**RECORD OF DECISION  
NIMO Glens Falls - Mohican Street  
Former MGP Site  
Operable Unit No. 1  
MGP Site and Canal**

**Glens Falls (C), Warren County, New York  
Site No. 5-57-016**

**March 2003**

## **RESPONSIVENESS SUMMARY**

FIGURE 3

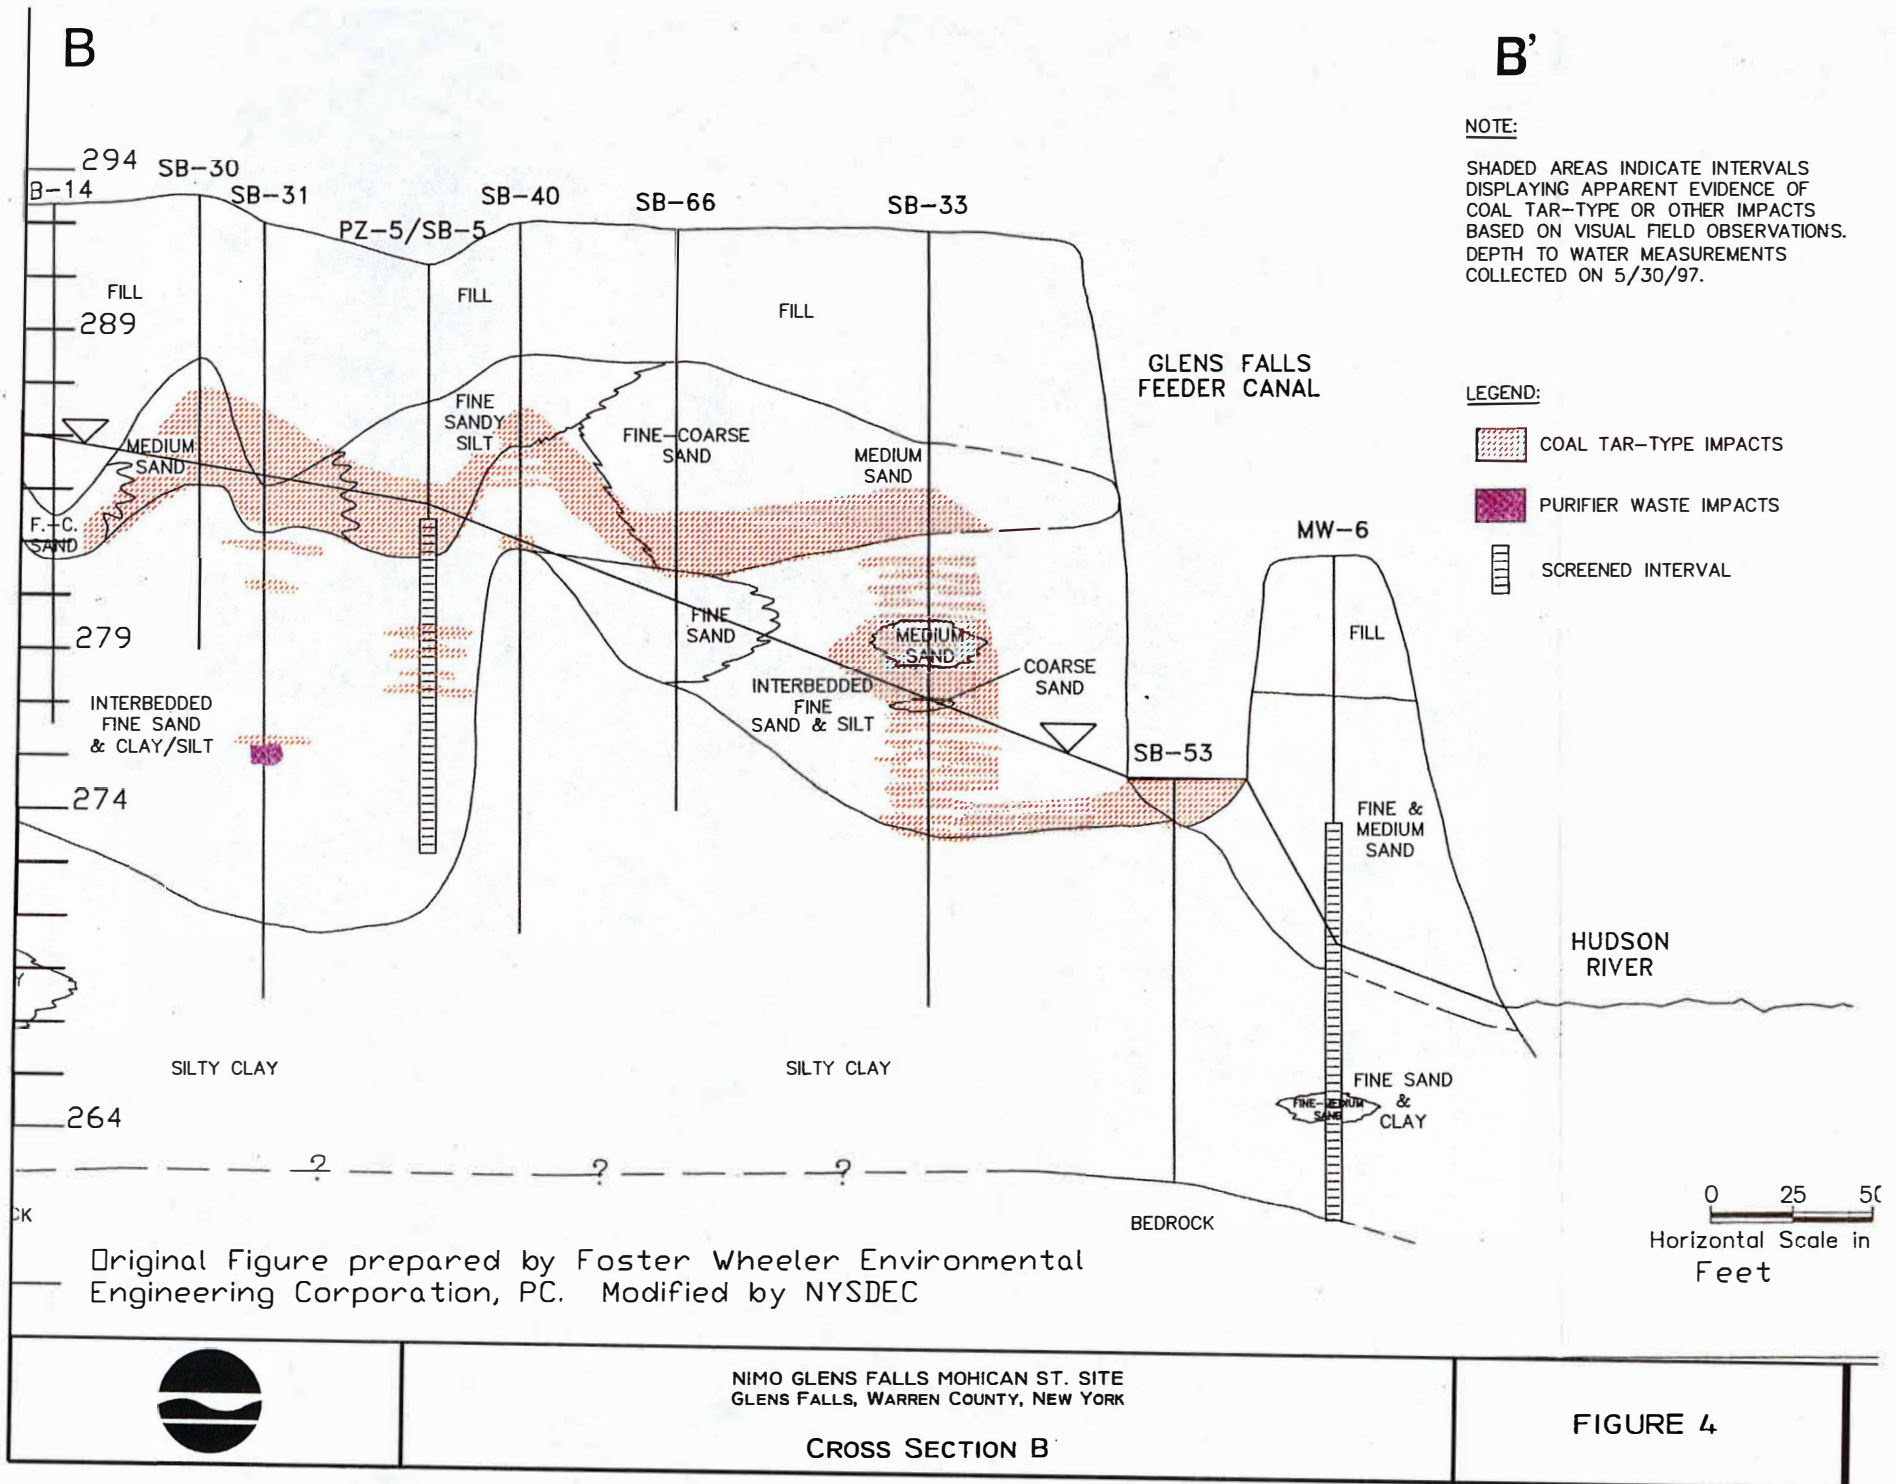
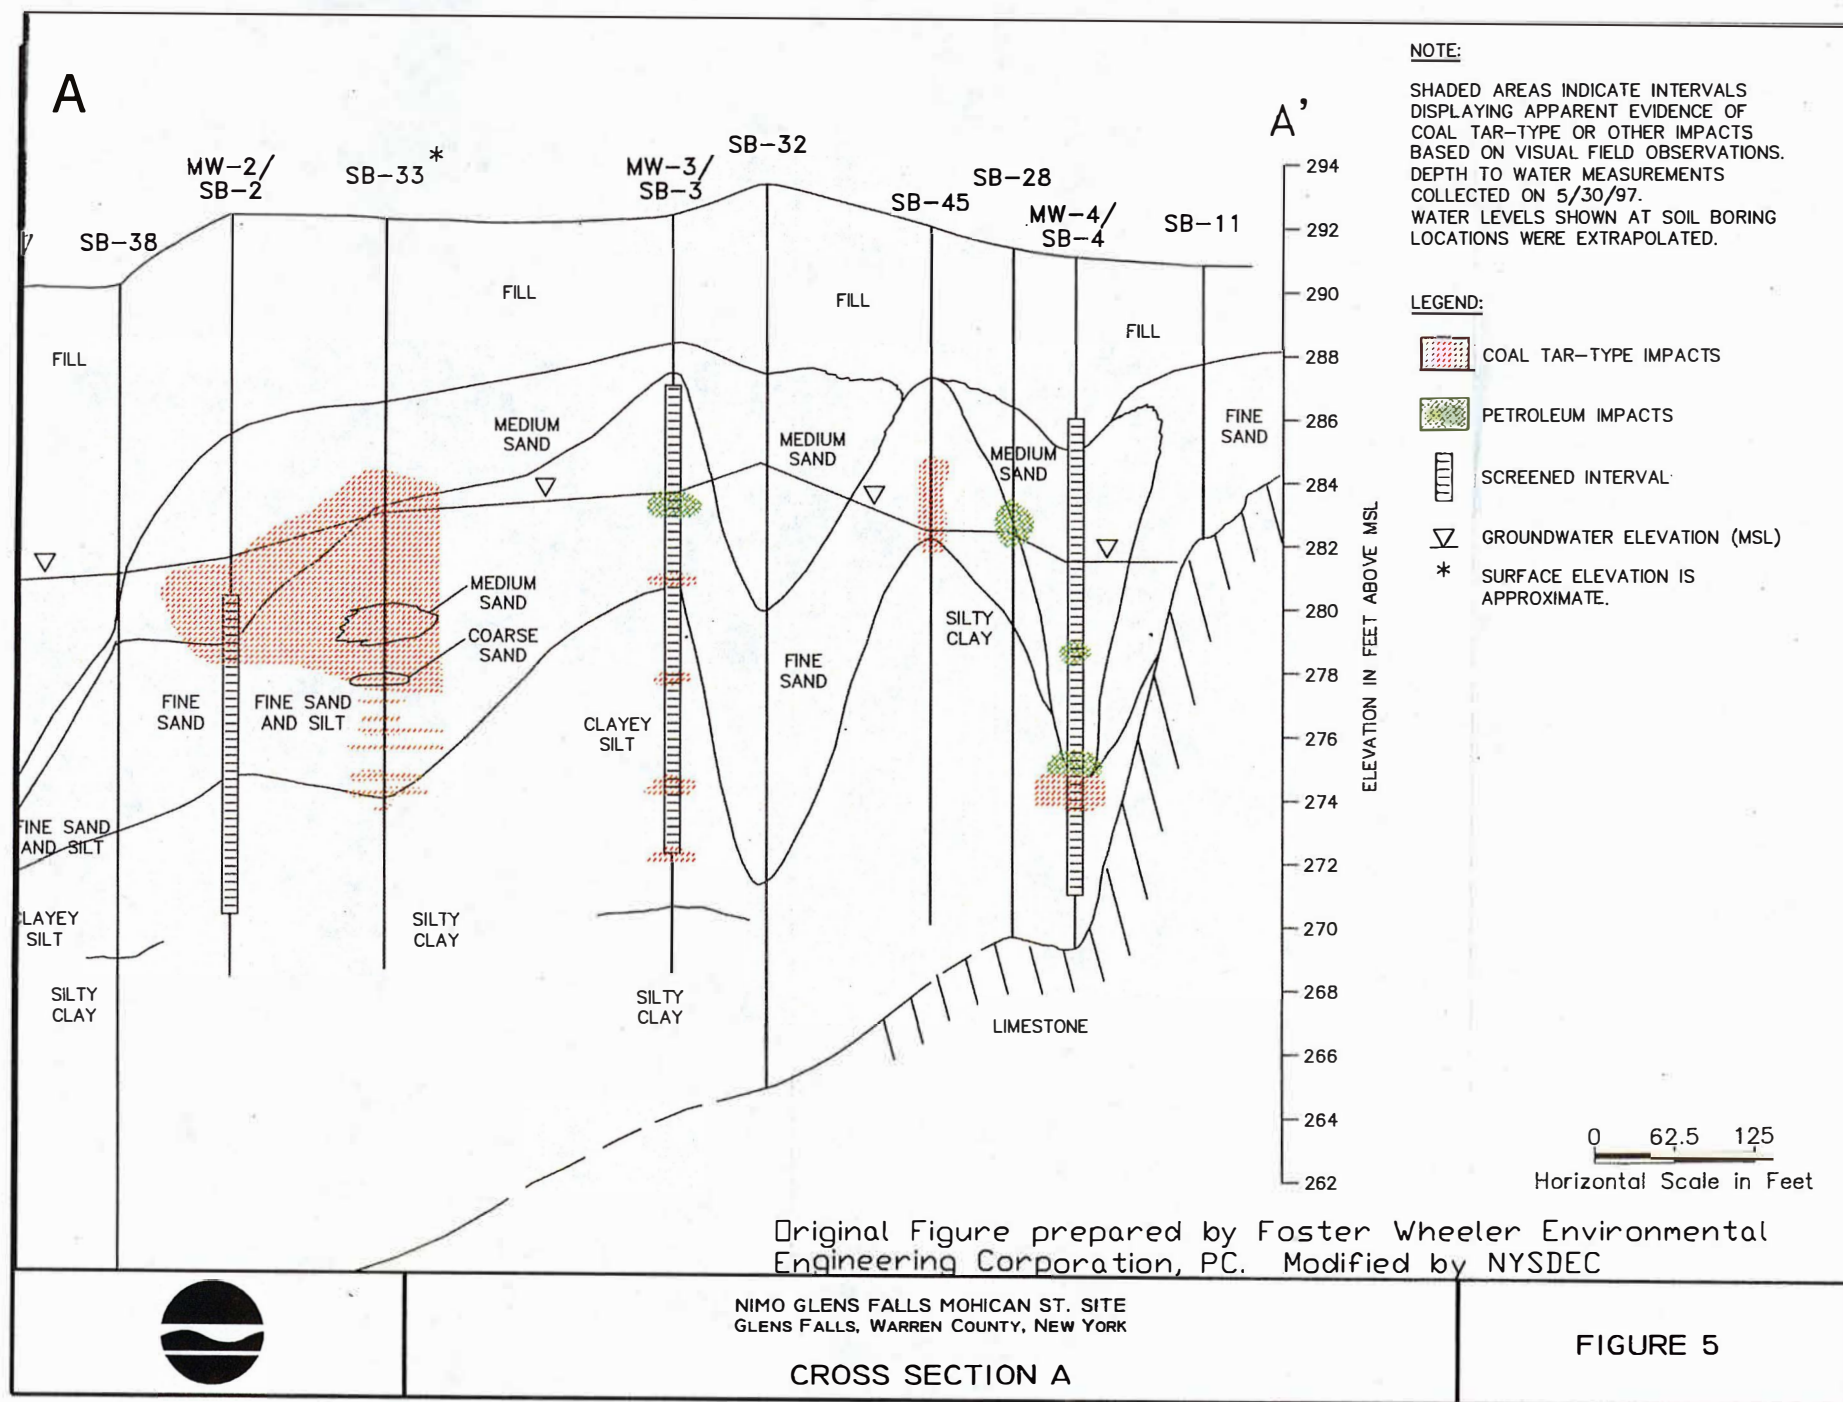
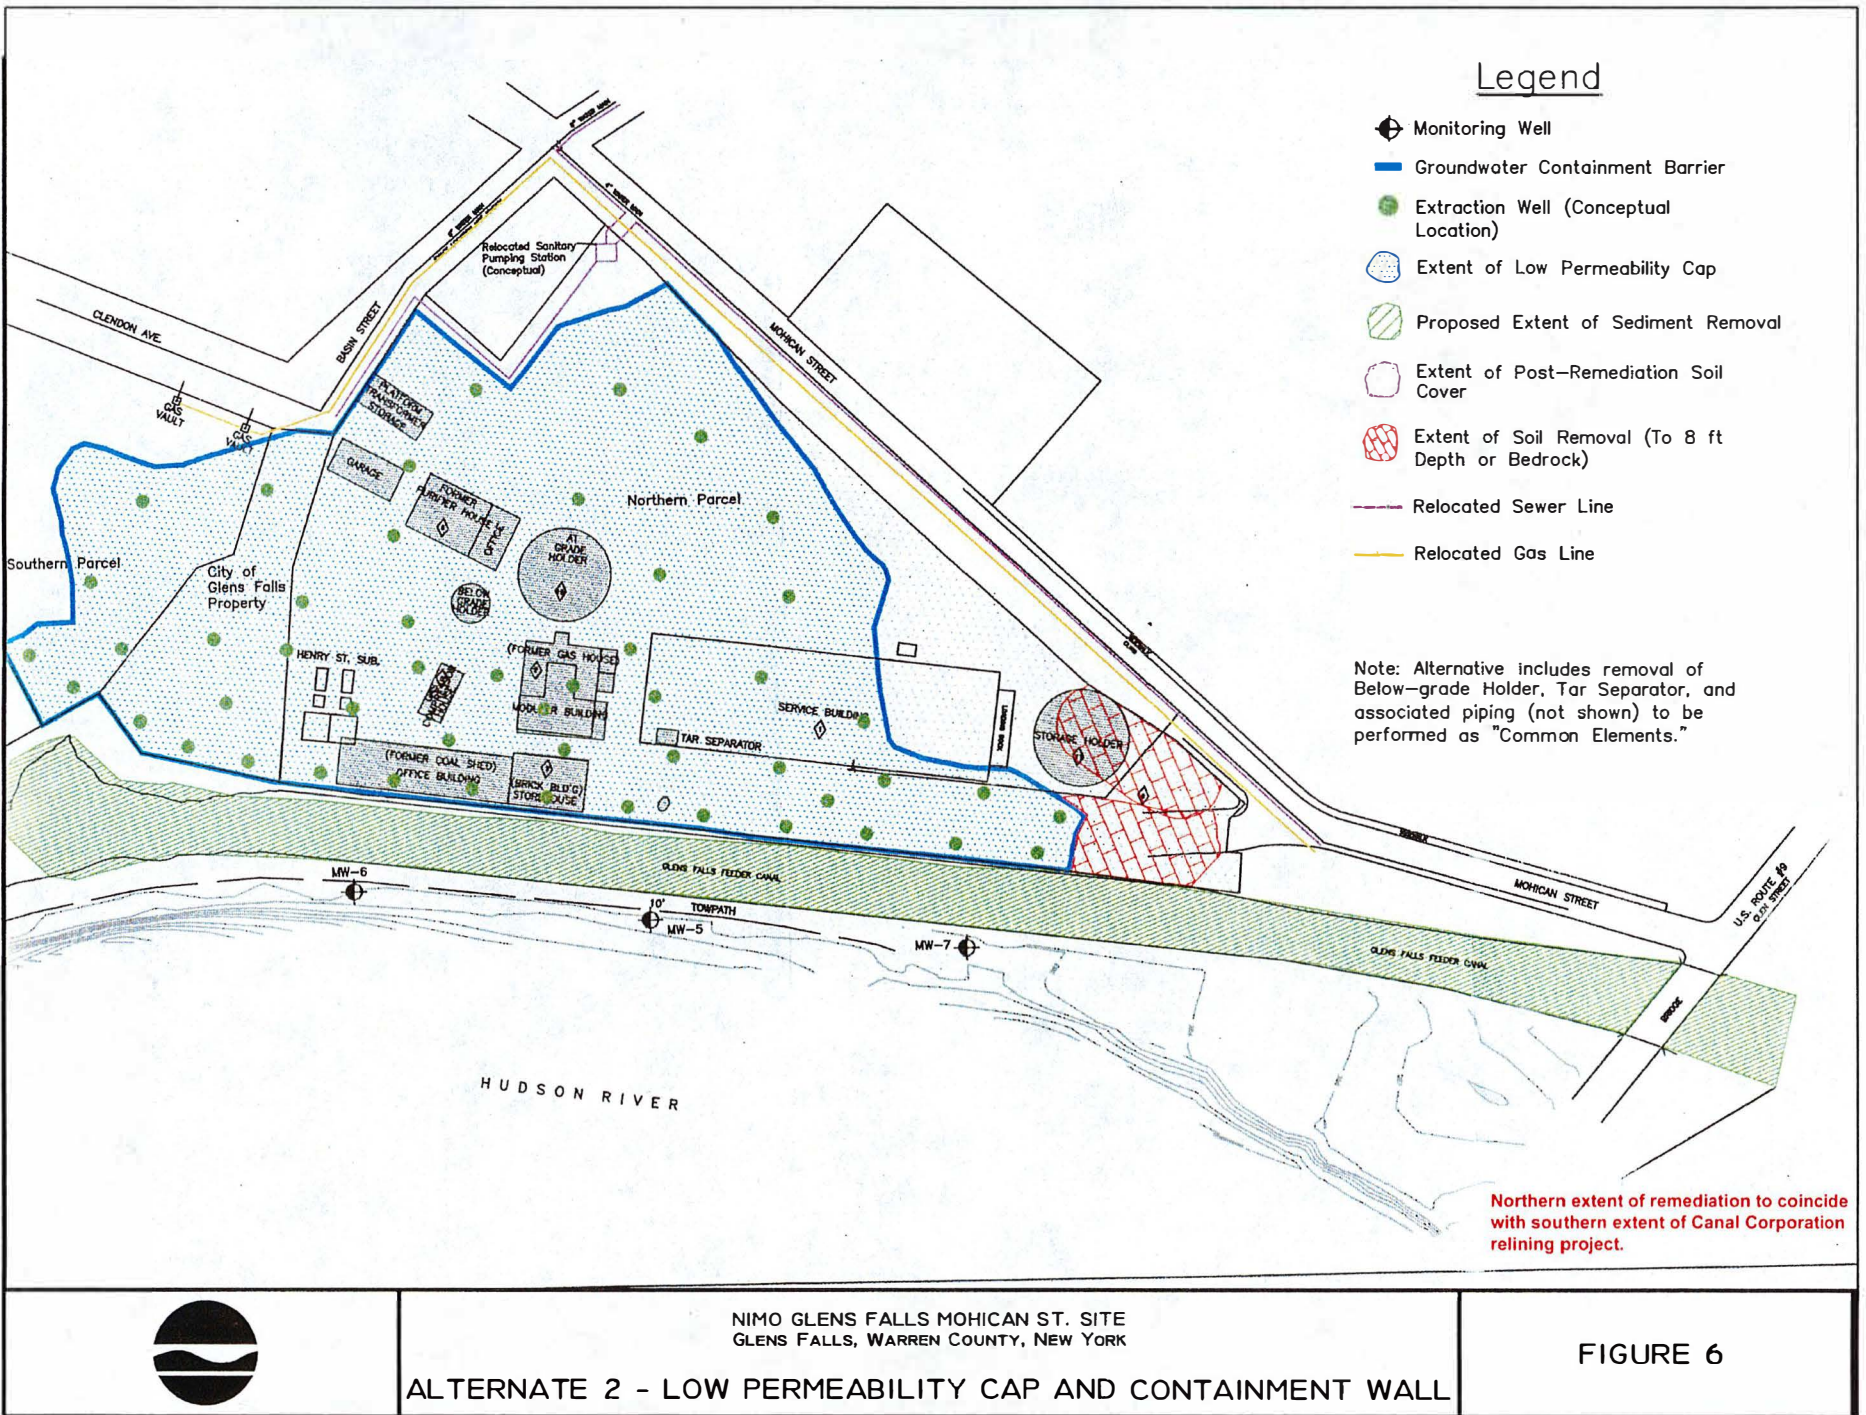
**Comment 60:** Page 9, 2<sup>nd</sup> column, last full paragraph, This paragraph should be revised to note that the cross sections depict BTEX and PAH impacts, not Source Areas so that the sentence now reads, "Please refer to Figures 3; 4, and 5 for cross sections that illustrates subsurface conditions at the site, and the identified subsurface BTEX and PAH impacts in relation to the former MGP structures."

**Response 60:** The sentence has been revised. The sentence now reads, "Please refer to Figures 3, 4, and 5 for cross sections from the SRI Report that illustrate the subsurface conditions at the site, and subsurface BTEX and PAH contamination in relation to the former MGP structures. Please refer to Figure 7 for the areas identified as, "source areas."

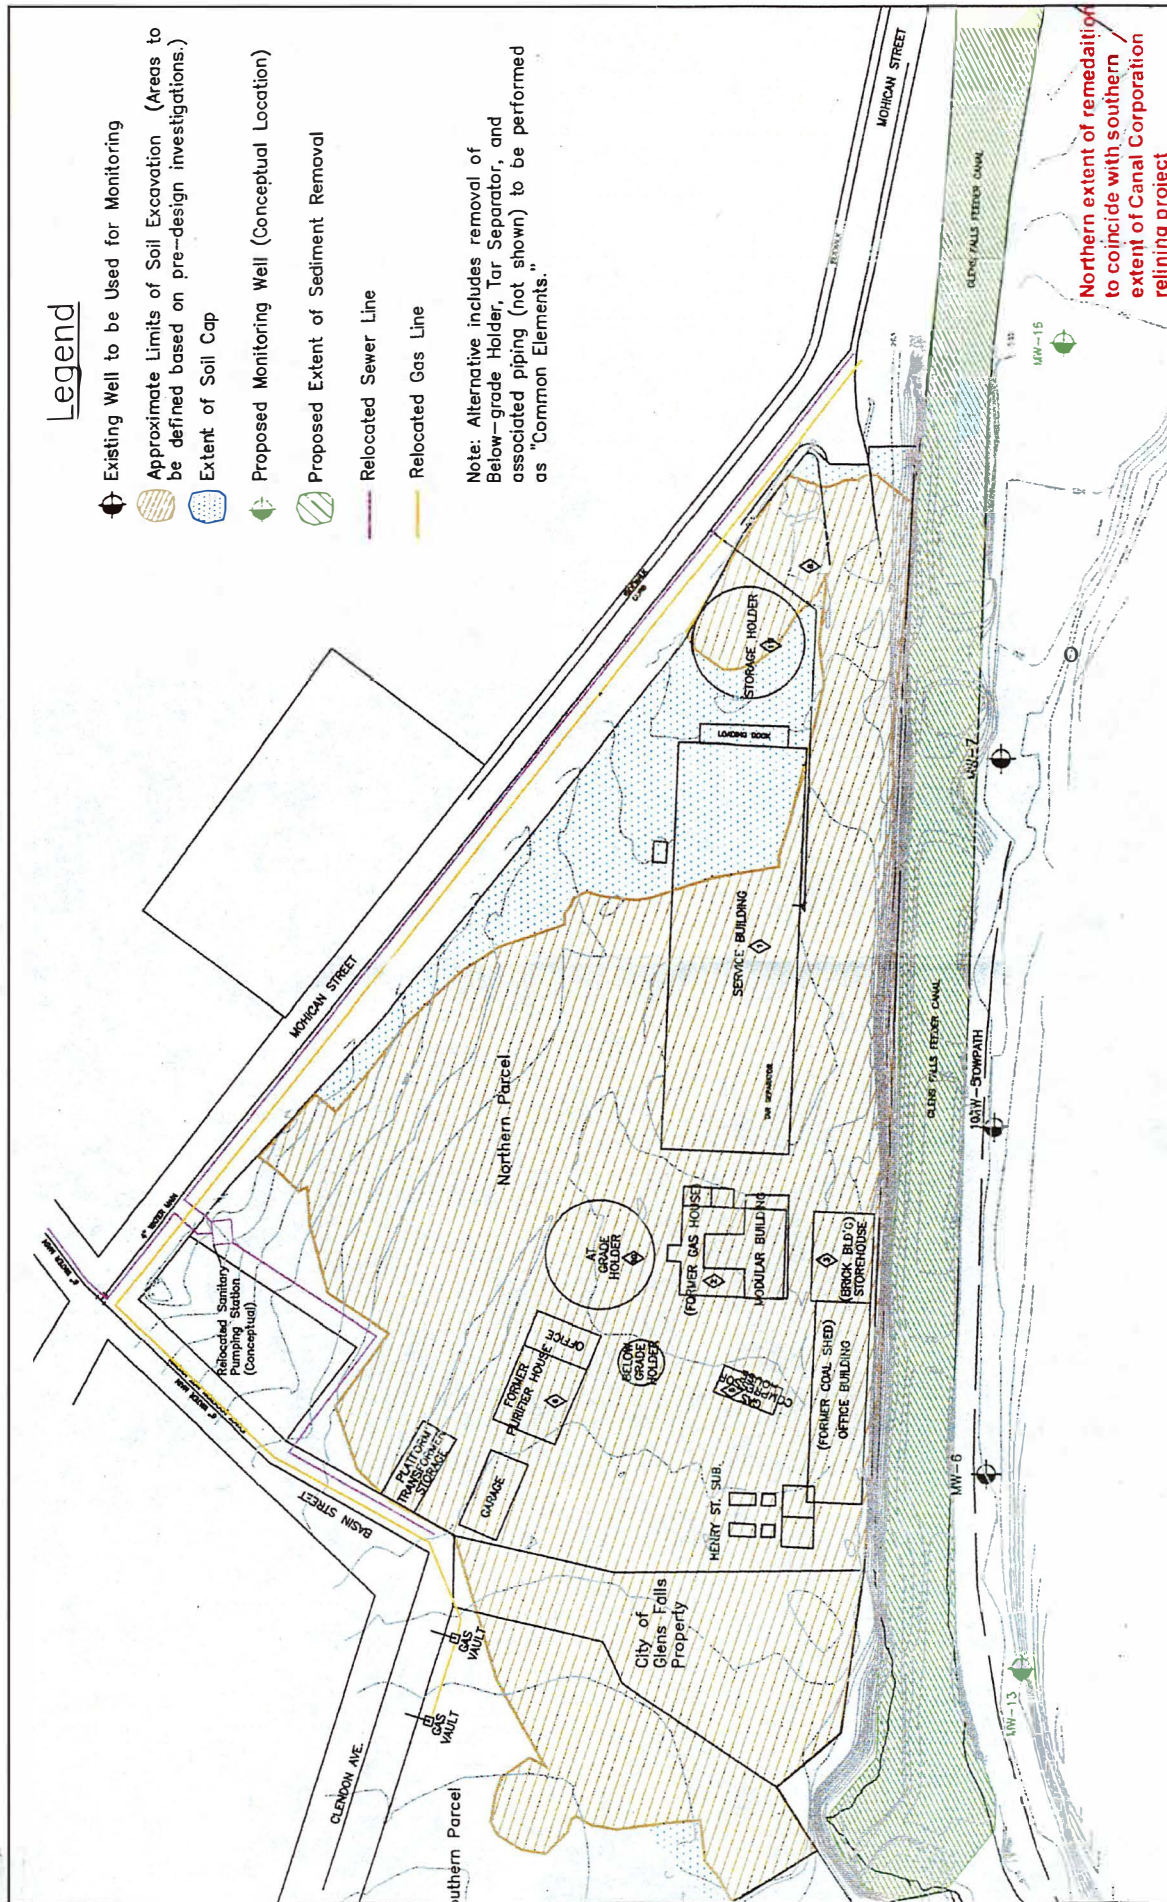
**Comment 20:** The Record of Decision should also reiterate that MGP structures containing significant volumes of soil saturated with NAPL within the polygon are the focus of the removal, as noted on Figure 7. As previously discussed with the Department, the feasibility and need to remove these structures should be evaluated during the predesign phase.

**Comment 29:** A general comment on Figure 7 relative to the "Service Building". NM would prefer to evaluate the need to keep the Service Building during the pre design activities. NM believes that the Tar Sump can be addressed without removal of the building.

**Comment 32:** The Record of Decision should clarify that the “Source Areas” subject to potential soil removal are limited to the polygon area on Figure 7 of the PRAP which contains structures D, E, F, G and H per the FS. A schematic representation of the preferred site wide alternative was presented in Figure 6-1 of the Final FS Report. This alternative encompasses locations where NAPL has not been identified in soil borings advanced at the site. Therefore, as agreed upon between NM and NYSDEC at our October 10, 2002, meeting the polygon

**Comment 37:** Figure 7 should clearly indicate what structures are associated with each letter.

**Comment 70:** Cross hatching in Figure 7 for areas of potential removal must be revised to be consistent with the legend.

**Response 29:** While the NM FS called for the demolition of the service building, which is the basis for this statement in the PRAP, the Department is open to reconsideration of the need, provided the agreed upon source area materials can be removed from the site. The crew facility will need to be demolished to install the barrier/treatment wall and remove source areas, as identified by the NM FS. The ROD has been modified accordingly.

**Response 37:** Figure 7 has been revised to address this item.
